PLANNING BOARD

622 Auburn Street; 165 Lambert Street
Major Site Plan Amendment
PL-002995-2024
Lambert Woods North, LLC, Applicant

Submitted to:	Portland Planning Board	Prepared By:	Sean King
Public Hearing Date:	September 24, 2024	Date:	September 20, 2024

Overall Logistics Plan 02.22.24

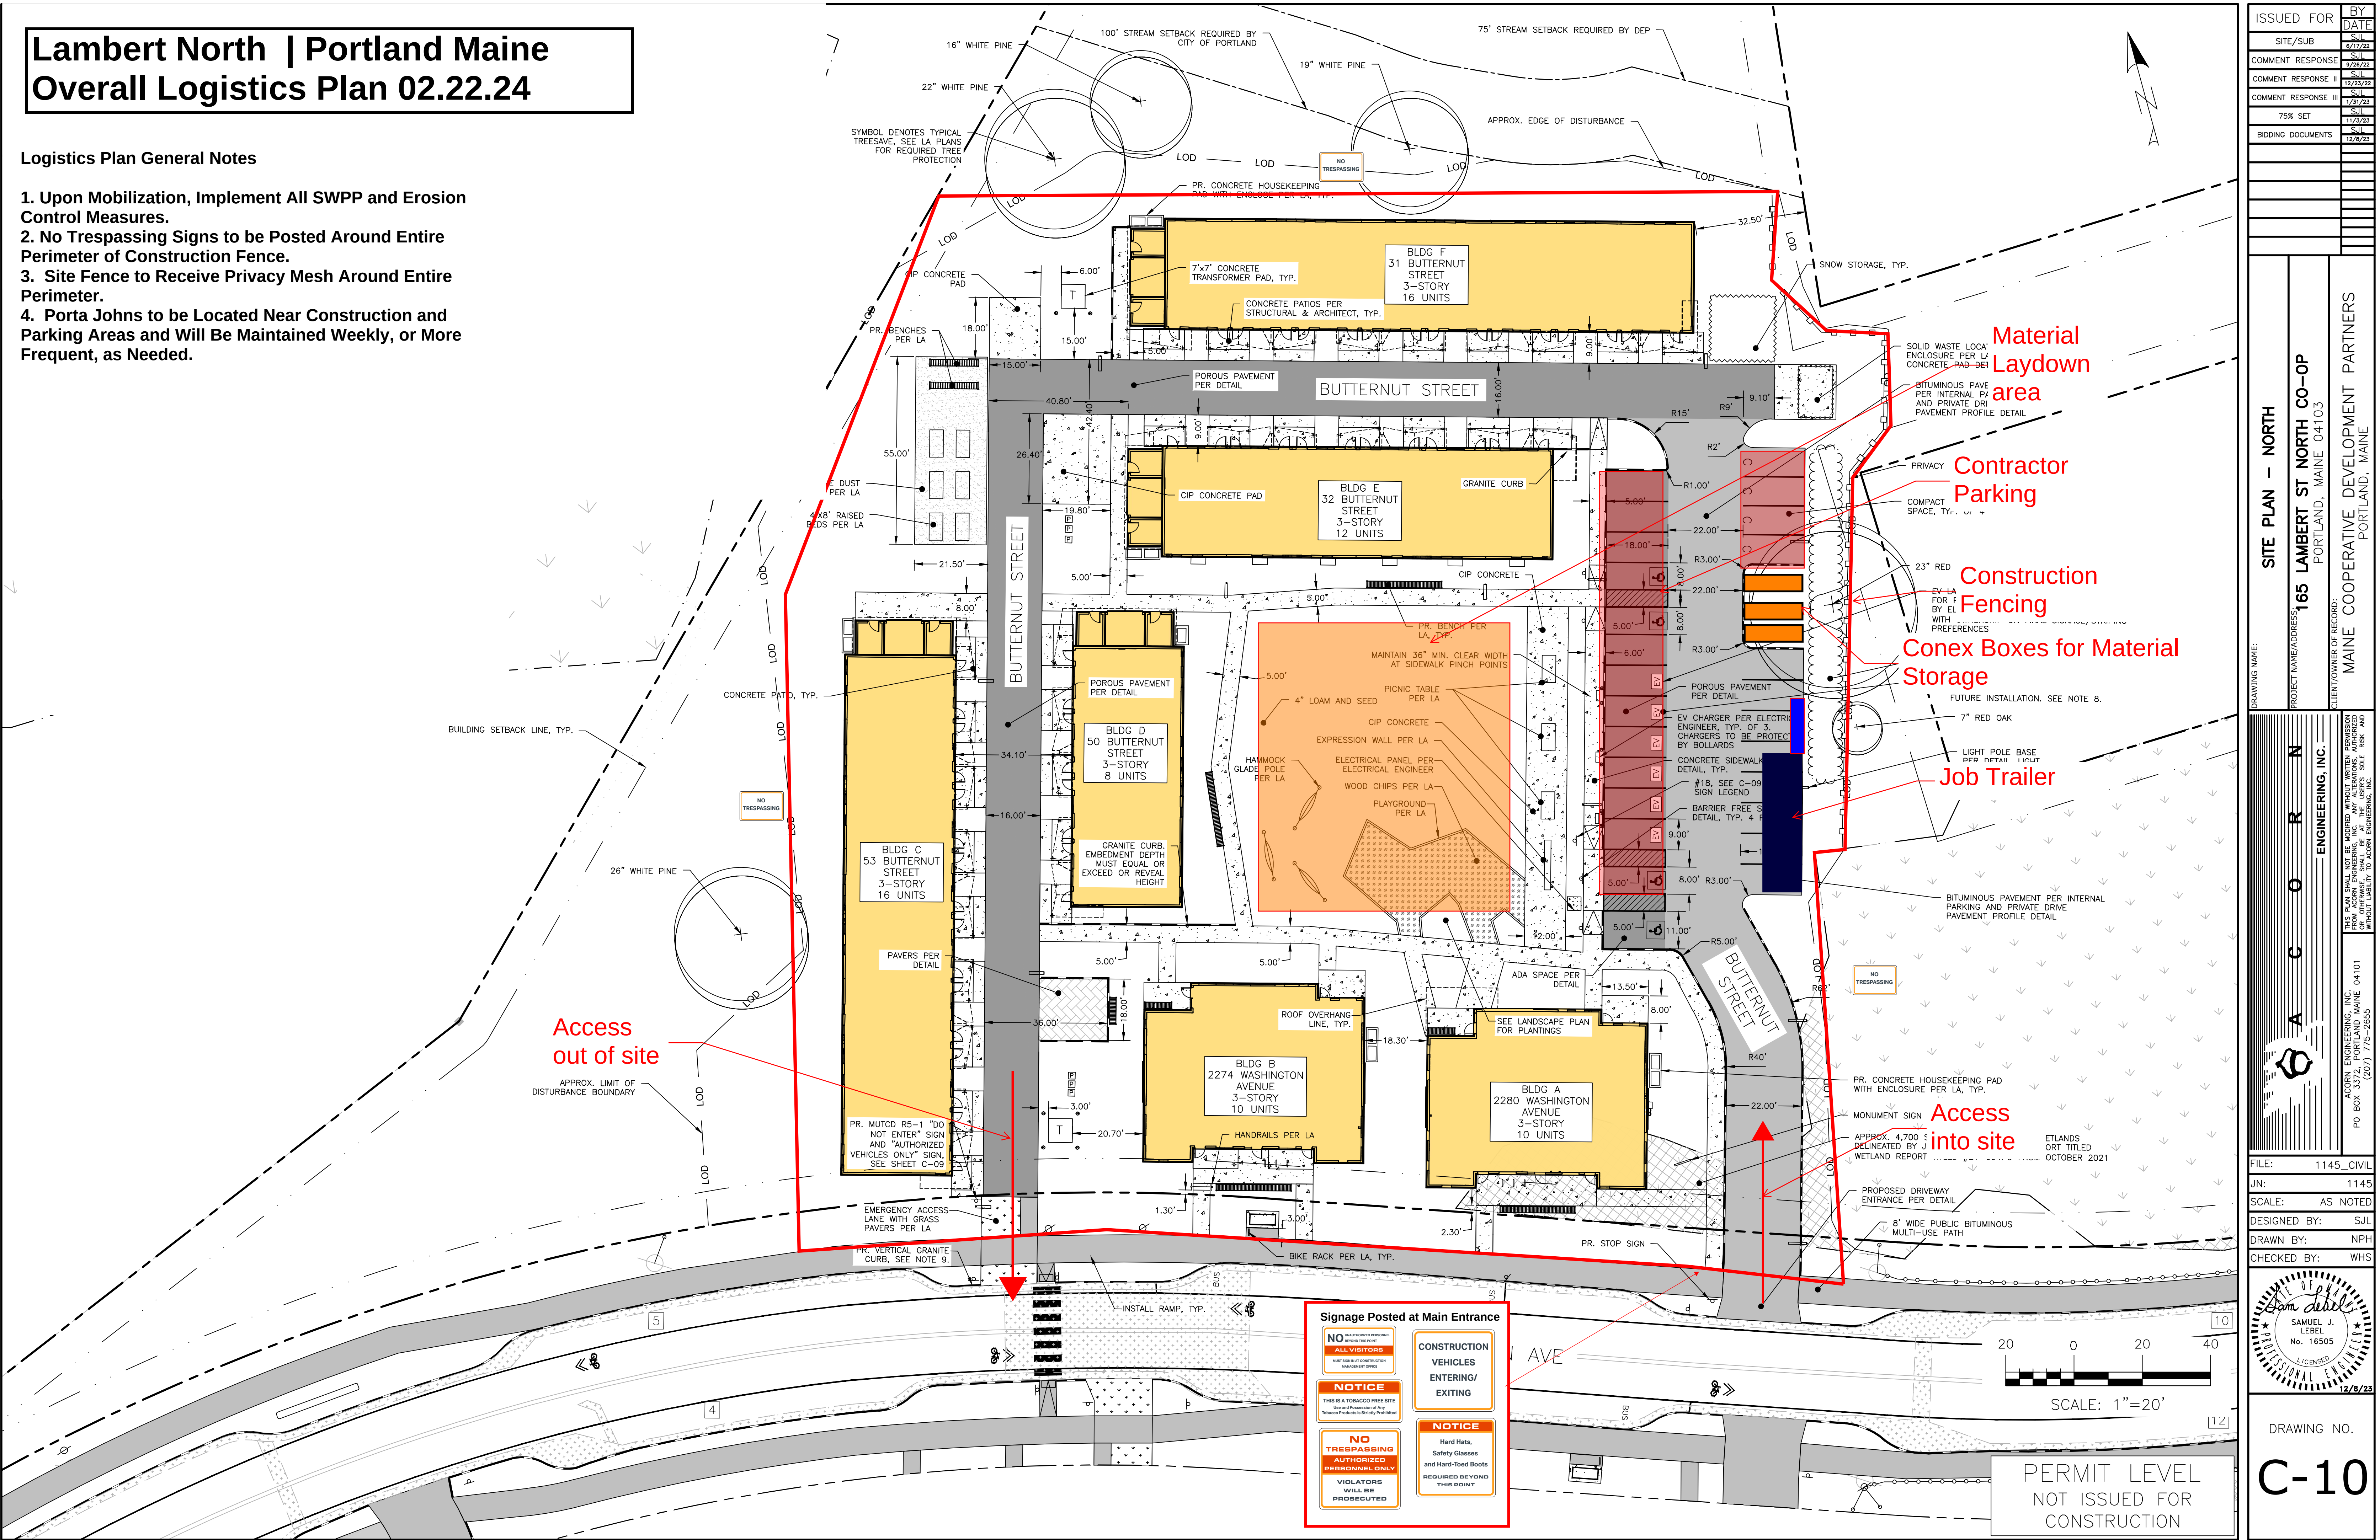
Response: See revised sheet C-03 that specifies check dams and erosion control blankets in the ditch line until established vegetation is present. Also note on C-41 the riprap check dams and plunge pool as a permanent measure to be installed until the storm drain connection to the Lambert Street intersection is completed during Phase 2. For Phase 1 it is proposed that the closed drainage system daylight into the southern ditch line near Sta 2+25 and flows along the short stretch of open channel to the existing terminal catch basin. The remainder of the closed drainage system including the connection to Lambert Street will be constructed as the southern parcel’s stormwater systems come online during Phase 2.

DRAWING NO. **C-50**

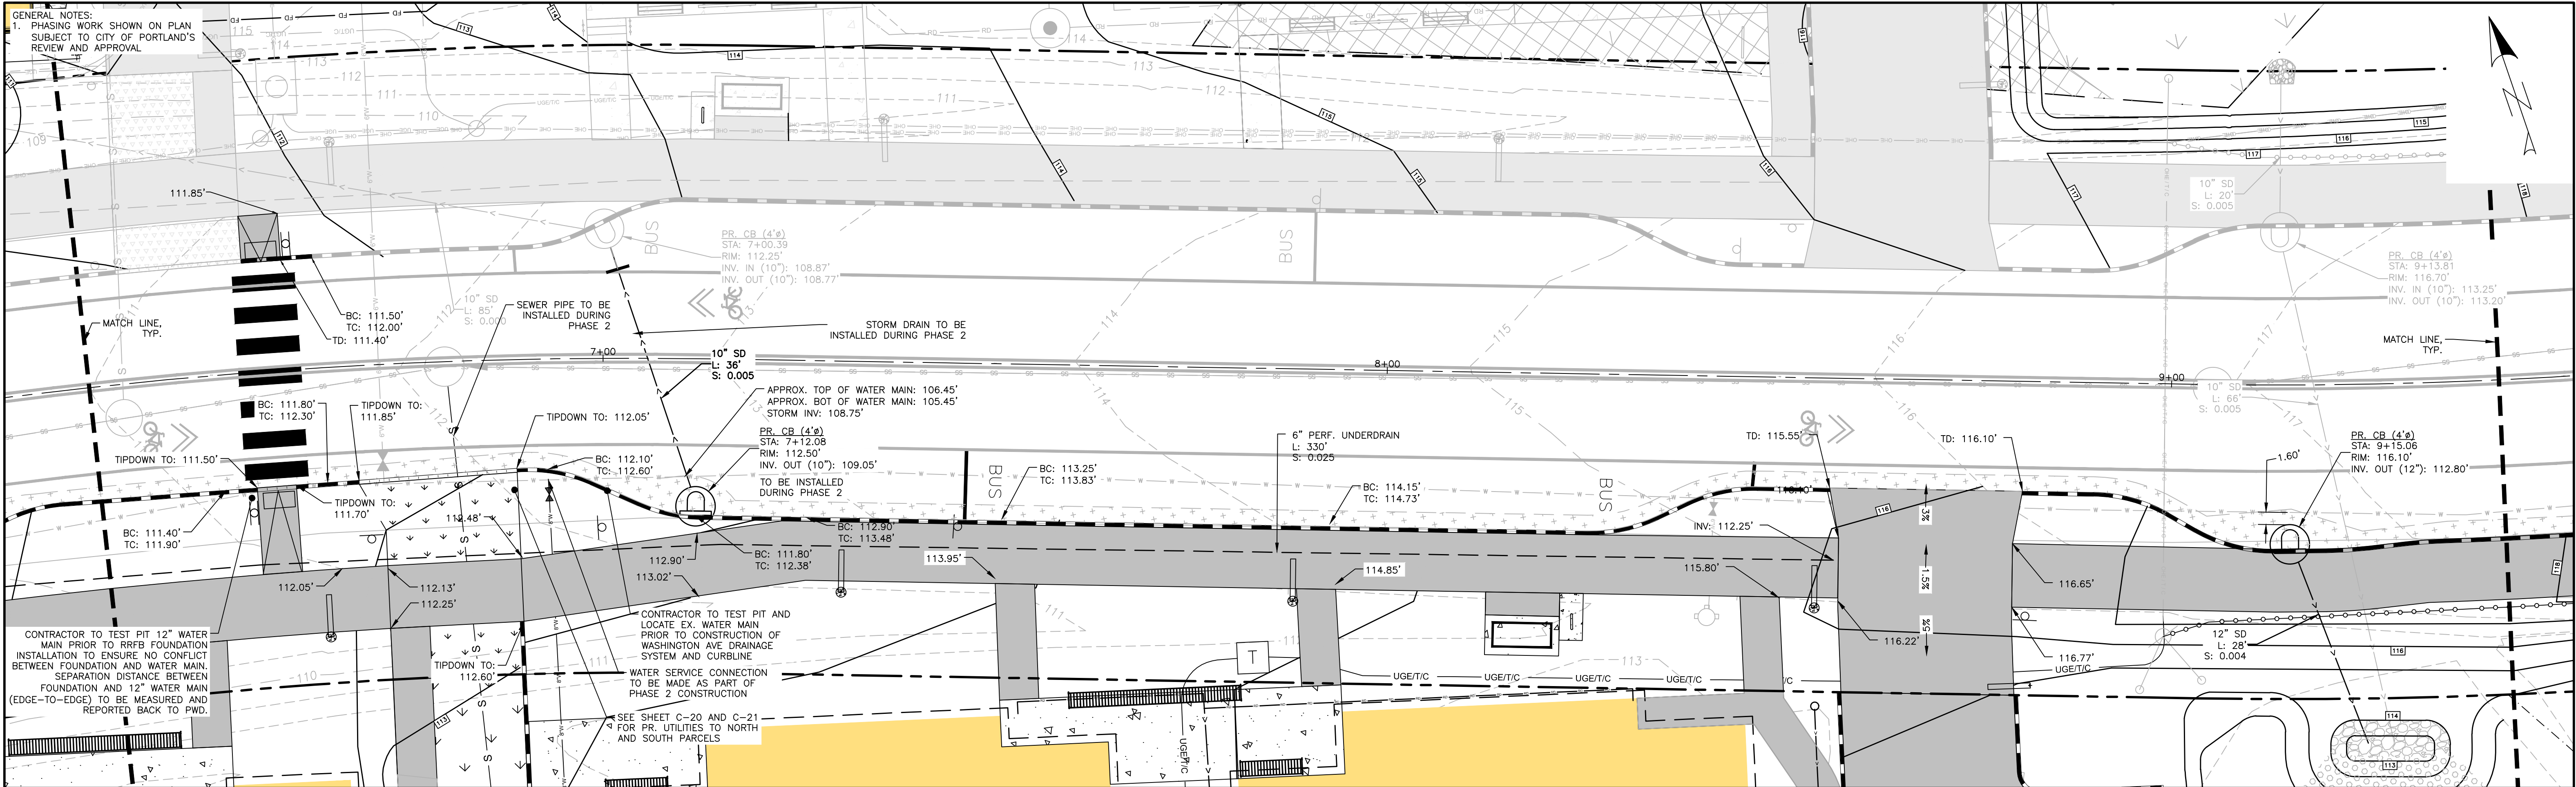
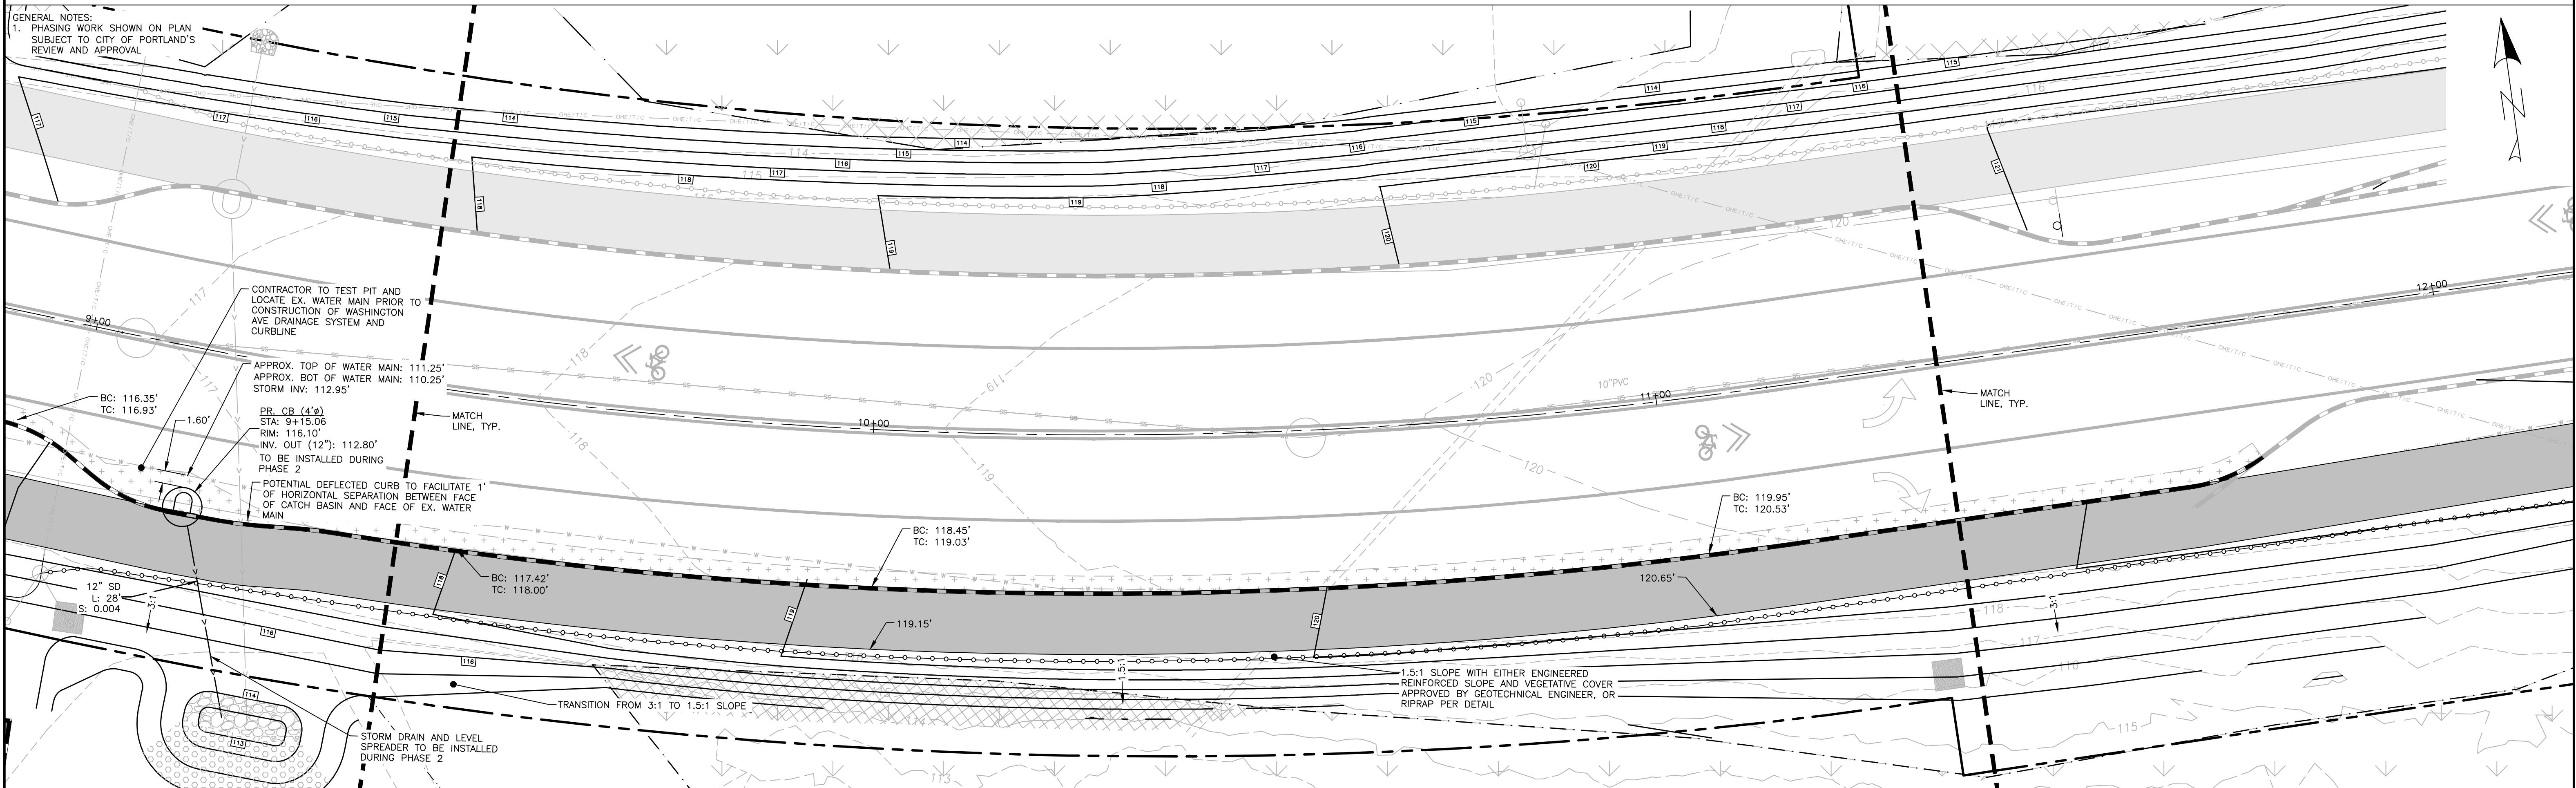
- **PL-002995-2024 165 Lambert Street** Major Site Plan Amendment
 - Comments for Review
 - DPW Transportation
 - The plans should include callouts to protect the existing right of way monuments, specifically on right of way grading and drainage sheets and anywhere else applicable. Additionally, the 2 monuments that appear to fall in proposed sidewalks call for monument boxes to be installed in accordance with the city monument detail (and standard detail I-8 added to the planset).
 - If any monument needs to be cut down to facilitate installing a monument box then the re-marking the monument needs to be performed by a licensed surveyor and coordinated prior to disturbance or work in the area. If a monument needs to be moved then it needs to be coordinated with the DPW Surveying group.
 -
 - DPW Water Resources
 - No comments
